**Real Estate
Assets**
City Consent Application

For installation / modification of Telecommunication antenna facility on City owned property

RE: Site Name: Seaworld San Diego Project # 607687
Site Address: 500 Seaworld Drive San Diego, San Diego (the "Property")
Agreement: Agreement dated 7/3/2018 (the "agreement") between The City of San Diego ("City") and _____, ("Lessee" or "Permittee").

Revise existing approved project #607687 See attached project description.

① **NODE #01 - ADMIN: ENLARGED SITE PLAN**

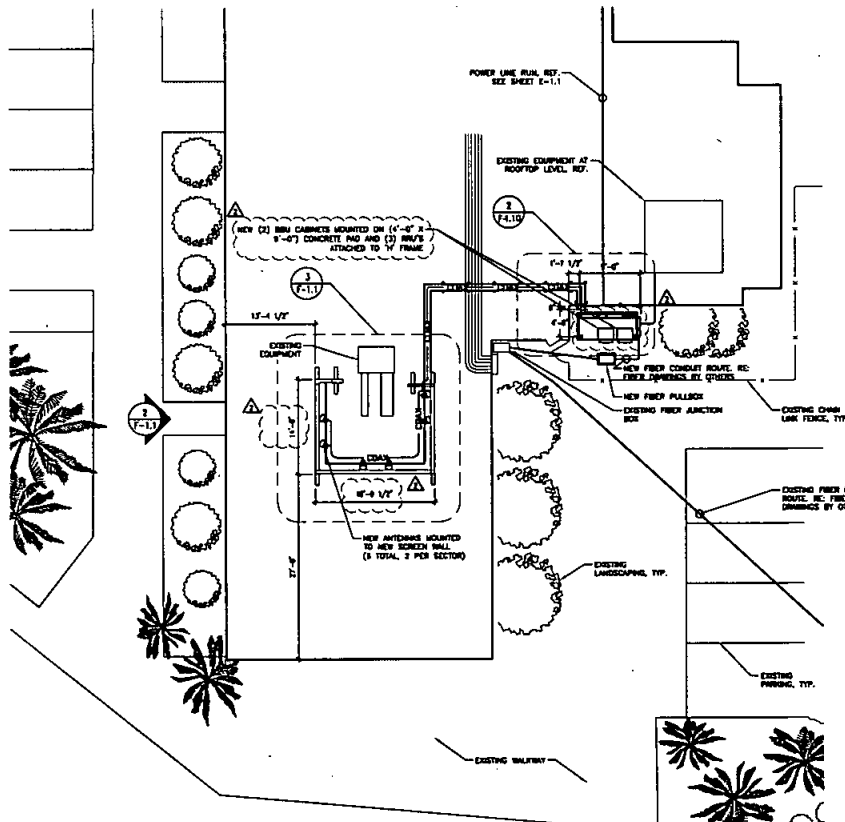
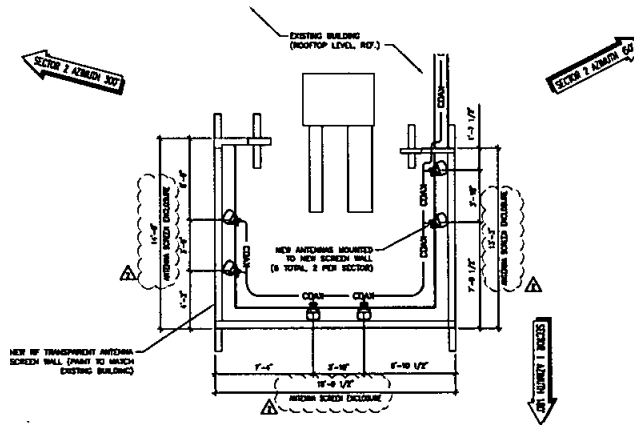
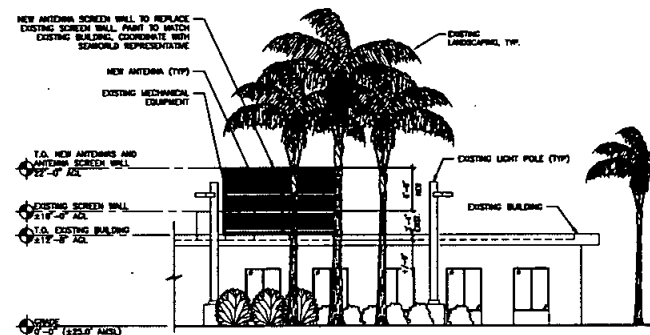
- No changes on HUB
- Node 1: equipment pad changed to 4'-0" x 9'-0". Removed transformer. Changed circuit breaker feeding equipment from 50A to 100A. Screen size changed. Added (1) BBU and (3) RRUs.

1 NODE #02 - AQUARIUM: ENLARGED SITE PLAN

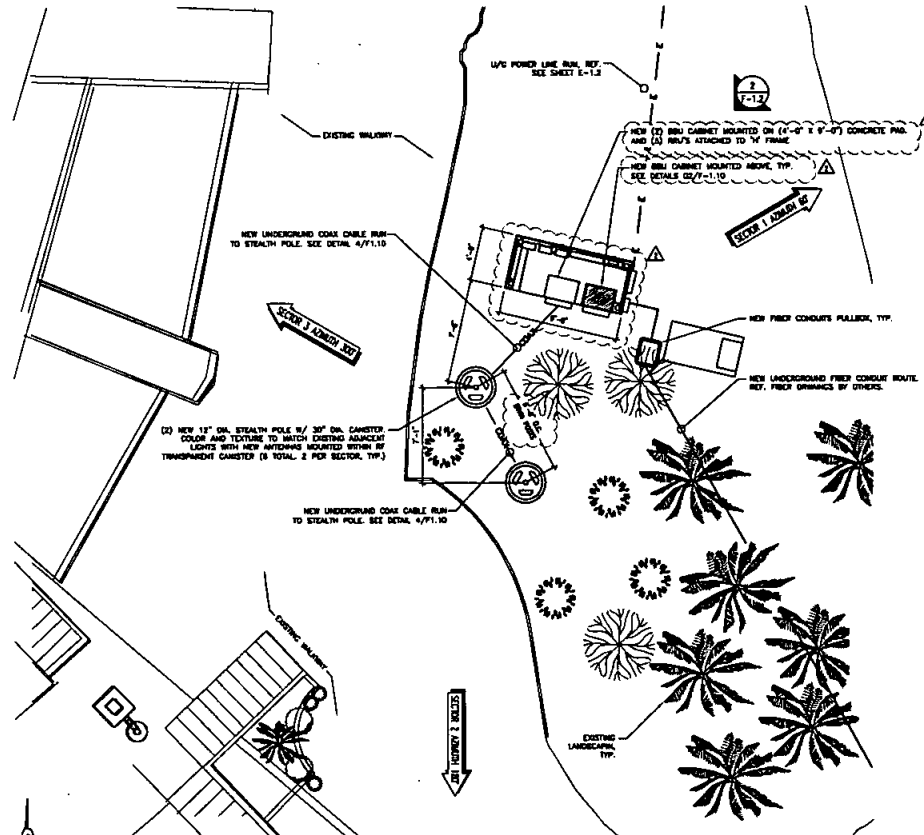
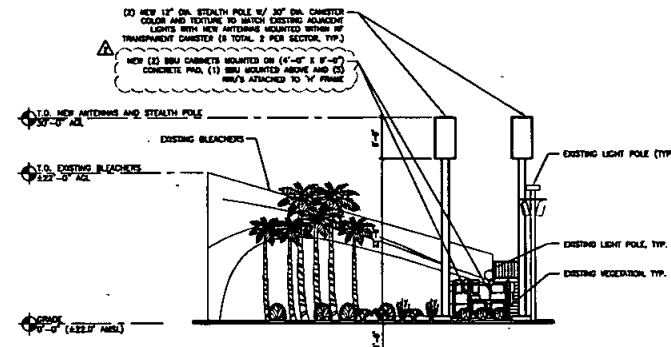
- Node 2: equipment pad changed to 4'-0" x 9'-0". Added (2) BBU cabinets and (5) RRUs. Revised SLD, install new 100a/3p, instead of reusing existing 70A/3P.

1 NODE #03 - ATLANTIS: ENLARGED SITE PLAN

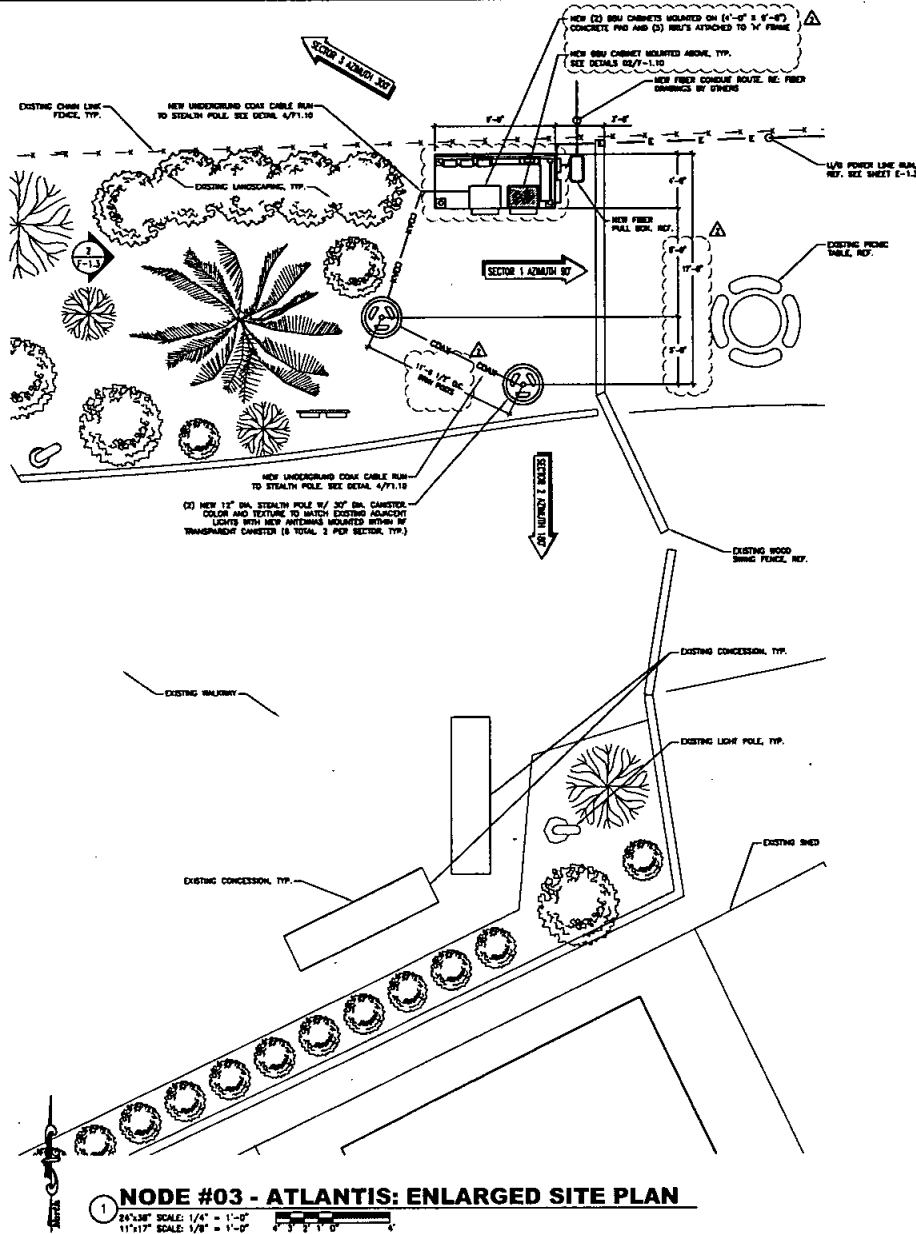
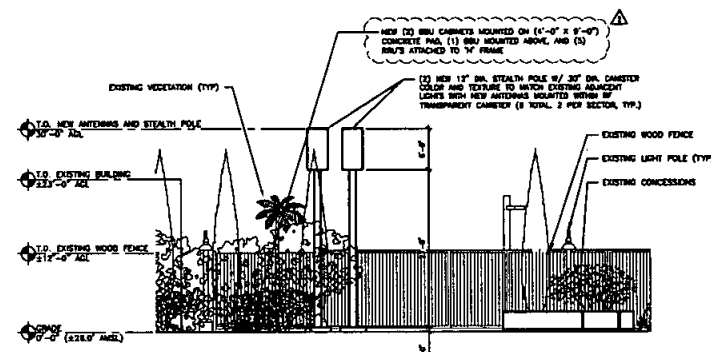
- Node 3: equipment pad changed to 4'-0" x 9'-0". Added (2) BBU cabinets and (5) RRUs.
- Node 4: equipment pad moved east. Equipment pad changed to 4'-0" x 9'-0". Added (2) BBU, (5) RRUs and fence.

1 NODE #05 - MAIN ENTRANCE: ENLARGED SITE PLAN

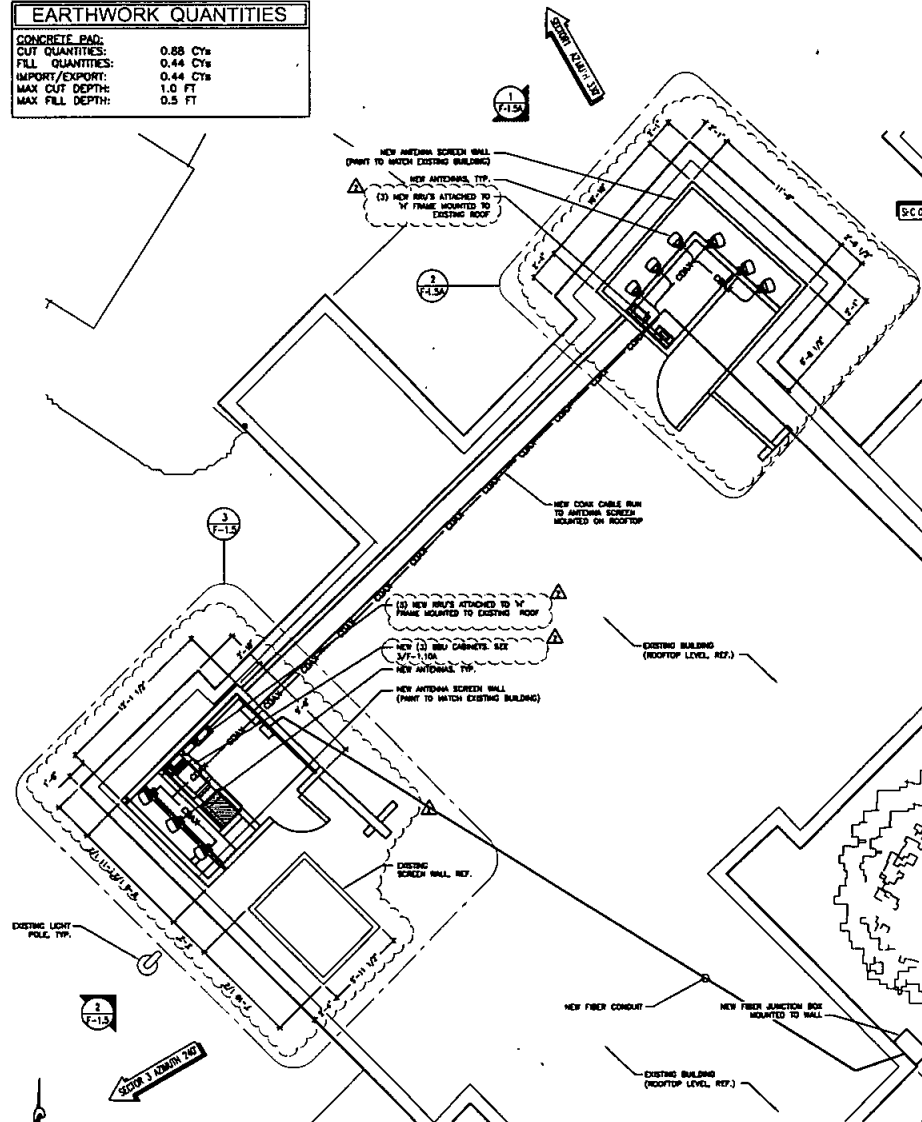
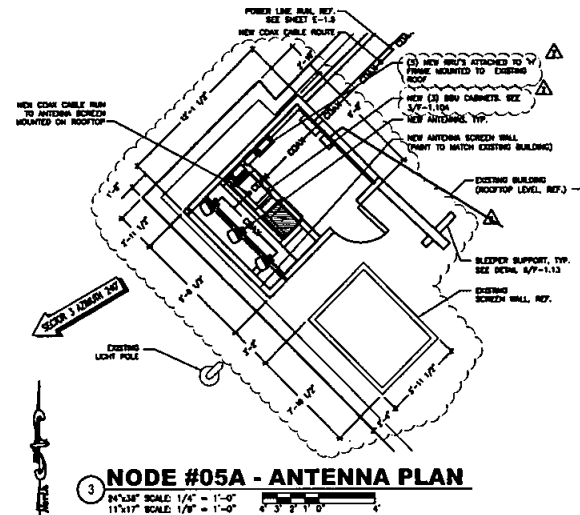
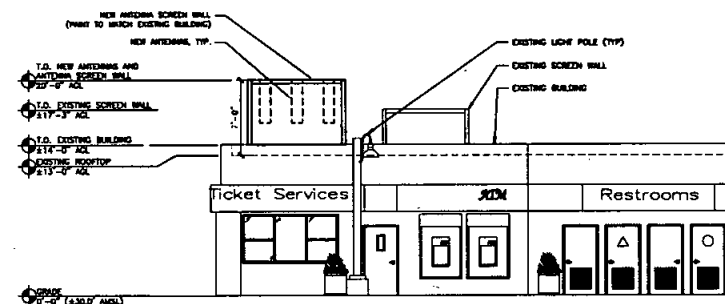
- Node 5a: added (2) BBUs and (5) RRUs. screen size changed
- Node 5b screen size changed and added (3) RRUs
- Node 6: added (2) BBUs and (5) RRUs. revised electrical conduit path from existing panel 'DP254' to "pole to pole" building

1 NODE #07 - SEA LION STADIUM: ENLARGED SITE PLAN

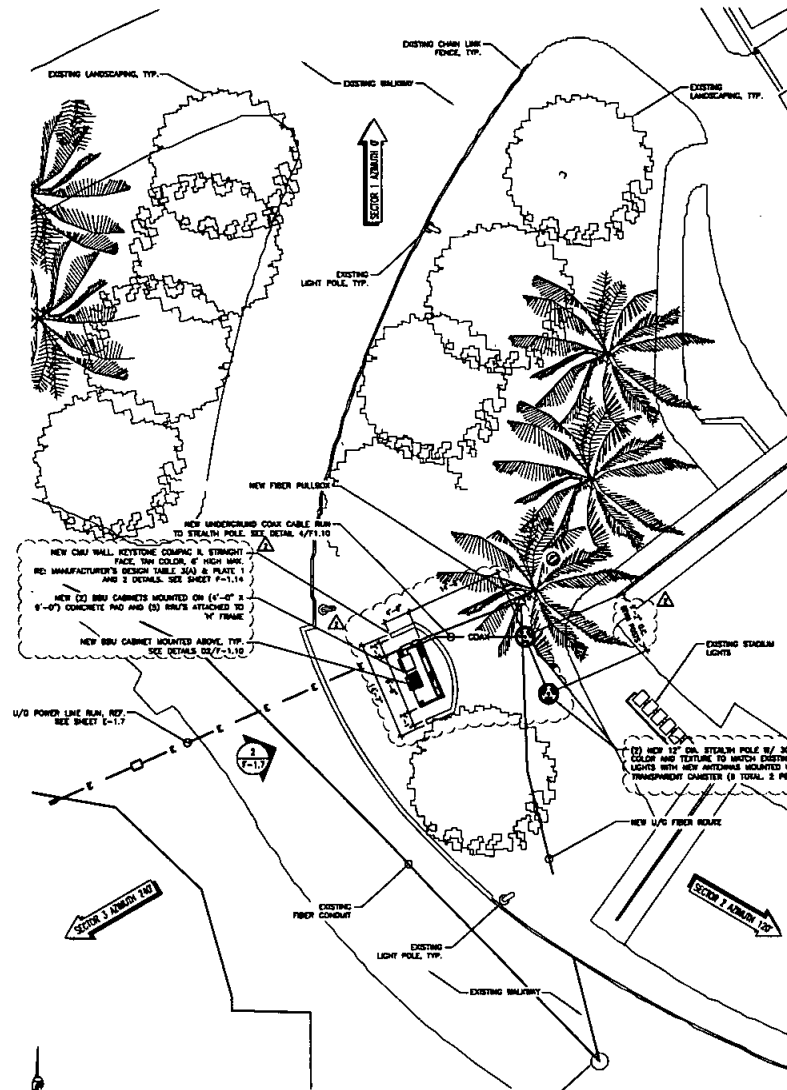
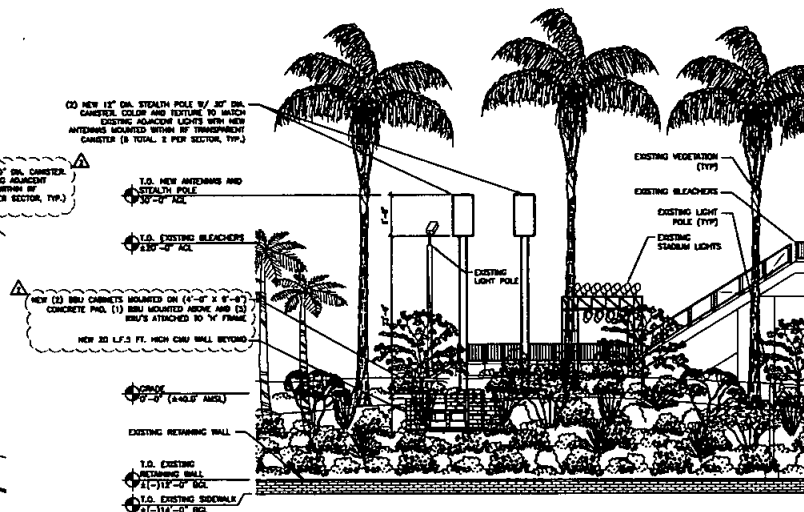
- Node 7: equipment moved south. Equipment pad changed to 4'-0" x 9'-0". Added (2) BBUs, (5) RRUs and CMU block wall.
- Node 8a: equipment moved south. Equipment pad changed to 4'-0" x 9'-0". Added (1) BBU and (3) RRUs.

1 NODE #08A - SHAMU STADIUM ENLARGED SITE PLAN

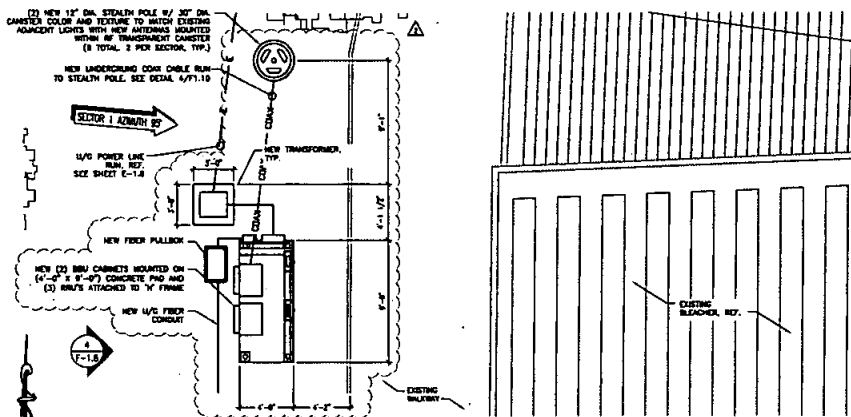
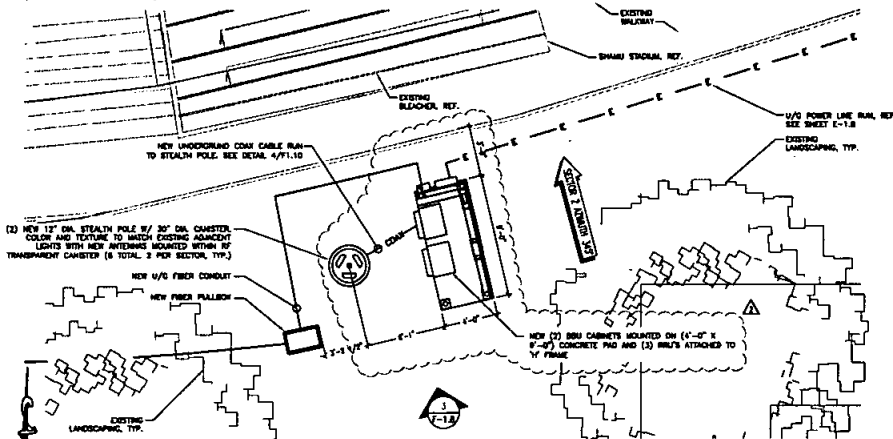
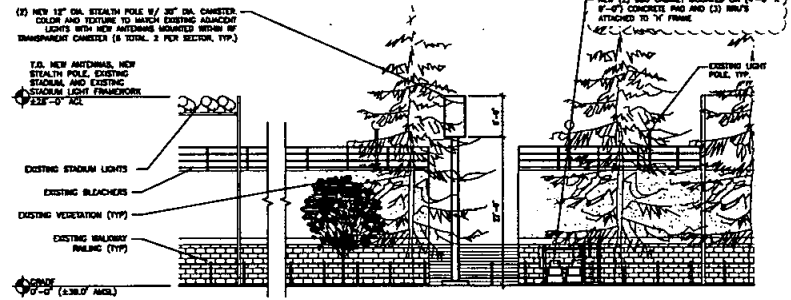
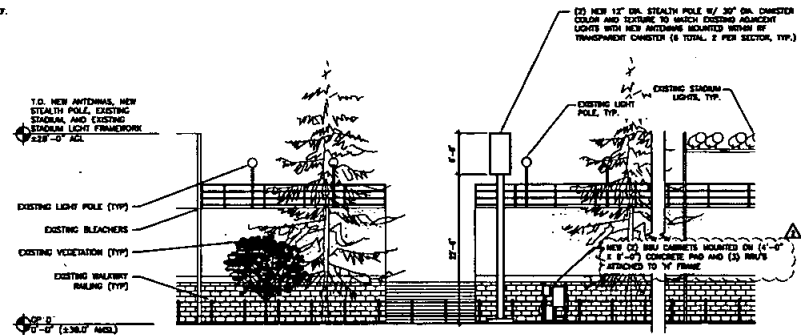
- Node 8b: equipment pad changed to 4'-0" x 9'-0". Added (1) BBU and (3) RRUs.
- Node 9: equipment pad changed to 4'-0" x 9'-0". Added (2) BBUs and (5) RRUs. Added wood fence/screen.
